SERVICE BULLETIN

M-1310

2009-2012 TOURING MODEL REAR STOP LIGHT SWITCH SAFETY RECALL CAMPAIGN 0145

Figure 1. Rear Stop Light Switch Identification: Sharp Edges Are Gone On New Switch

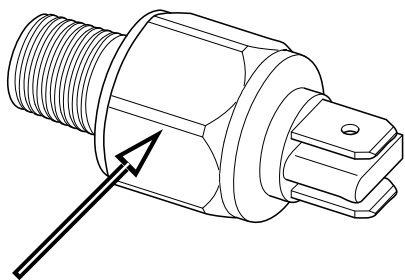
Harley-Davidson has determined that a condition affecting motor vehicle safety exists on certain Touring Models. The affected model motorcycles may experience a non-functioning stop light and/or cause a brake fluid leak through the rear stop light switch affecting rear brake performance. This could result in a crash, which could cause injury or death to the rider.

Table 1. Kit Part No. 91500011 Contents

ITEM	PART NO.	QTY
Rear stop light switch	*72016-06A	1
*non-sold part number
